Aligning specifications to module insertion loss allocation

(comments #58 and #60)

IEEE P802.3dj Task Force

January 2026 (r0)

Module input calibration

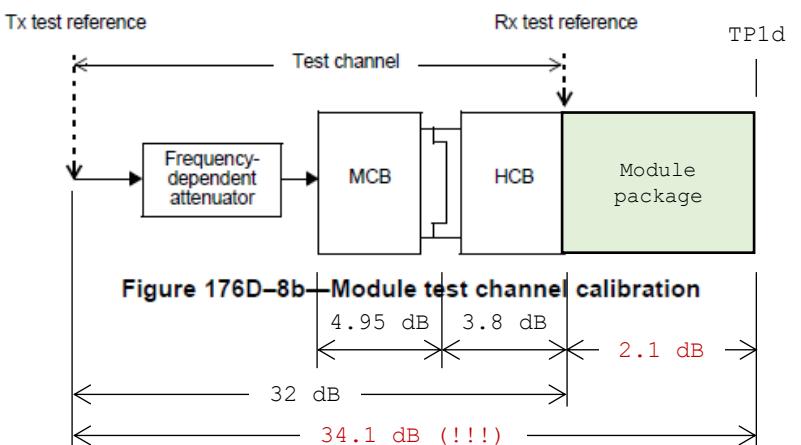
Assumed module loss is too high!

176D.8.13.2 Test channel calibration

The COM of the test channel is calculated using the method defined in Annex 178A and the parameters of 176D.7.2, with the following considerations:

- For the host test, the test channel is measured between the Tx and Rx test references shown in Figure 176D-7b, and COM is calculated using the partial host channel, device package, and device termination models in Table 176D-6 for the receiver S-parameter model.
- For the module test, the test channel is measured between the Tx and Rx test references shown in Figure 176D-8b, and COM is calculated using the ~~module device package and device termination models~~ in Table 176D-6 for the receiver S-parameter model. ~~Calculation is performed for both case 1 and case 2 of the package transmission line 1 length, and the value of COM is taken as the lower of the two calculated values.~~

Specification limits recalculated using the corrected model

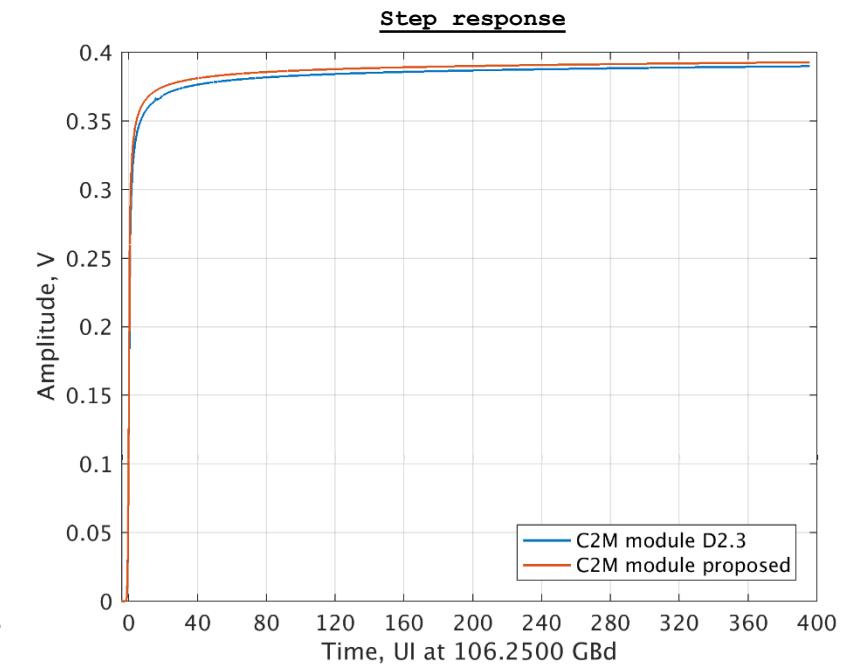
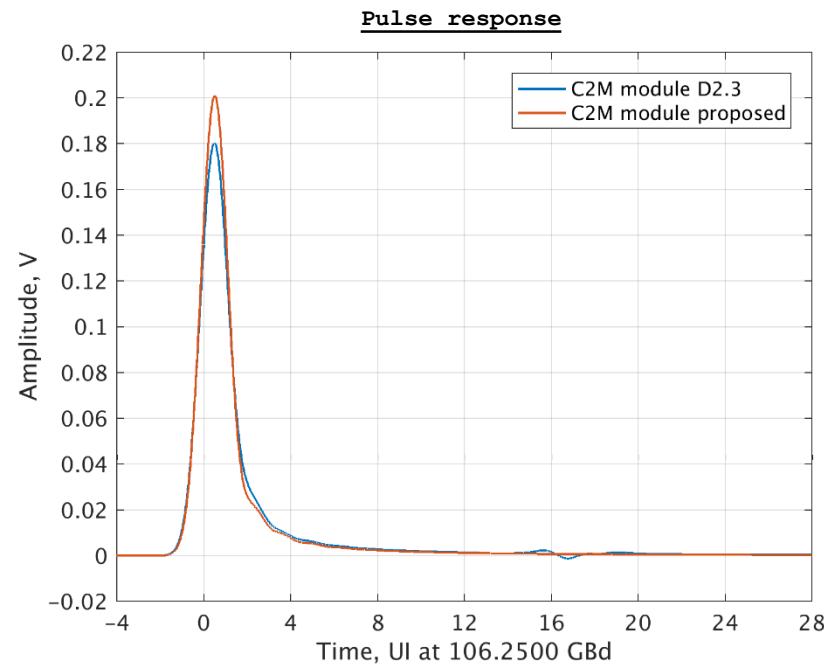
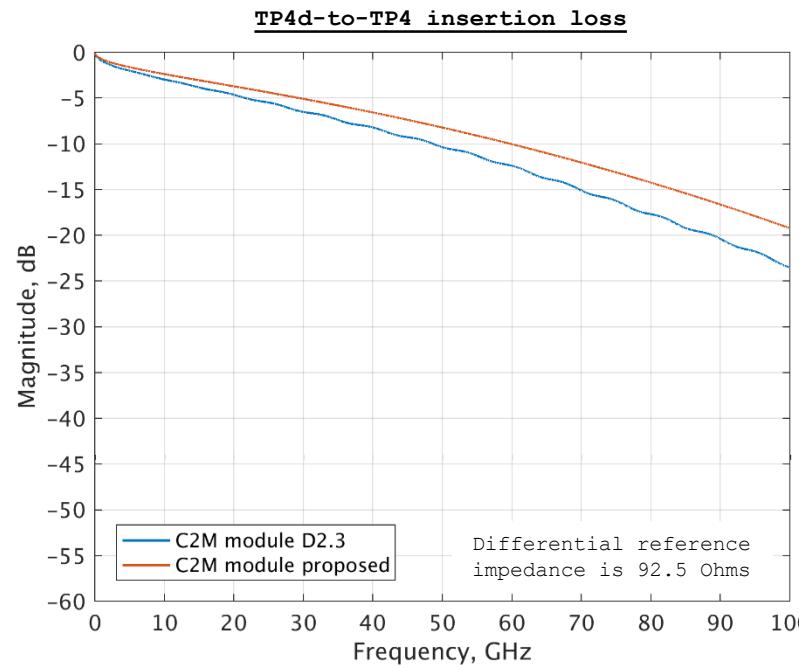
- In [healey_3dj_01a_2511](#), module output specification limits were derived from the Channel Operating Margin (COM) model of a module transmitter and the mated test fixture reference insertion loss
- Limits were computed with a module device package model in addition to the host compliance board
- This was consistent with the interference tolerance test calibration but not consistent with the module loss allocation
- If the interference tolerance test calibration is corrected, then the module output specification limits should also be revisited

Note that the transmitter device model includes the device termination model and the input rise time filter

Case	Package		Insertion loss, dB			p_{max} , v	v_f , v	R_{peak}
	Class	Length, mm	Mated test fixture	TP4d-to-TP4				
C2M module, D2.3	A	10	8.75	10.82		0.179	0.389	0.46
C2M module, proposed	n/a	n/a	8.75	8.75		0.2	0.392	0.51

- Remove module device package model from module interference and jitter tolerance test calibration
- Update module output R_{peak} and v_f limits to be consistent with its insertion loss allocation
